CONTRACT NO. M.W.S.B. 1398

CONTRACT 1: RAW WATER PIPELINE

ADDENDUM NO. 1

September 11, 2017

4 TYPICAL DETAIL 1:25
 WELL PUMP

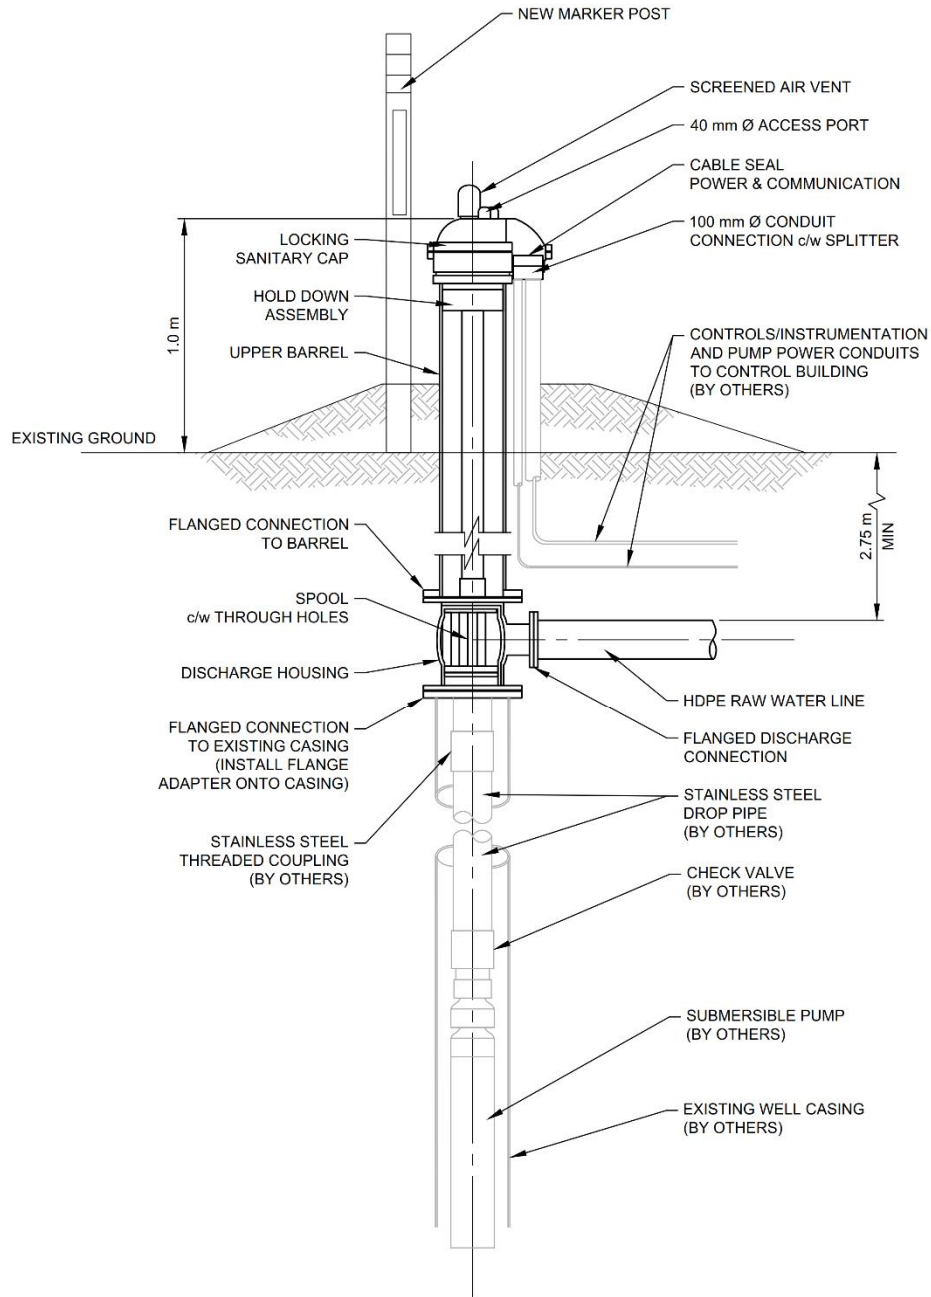
1.5 DRAWING 4977-00-C-102

.2 Replace typical detail 4 with the following:
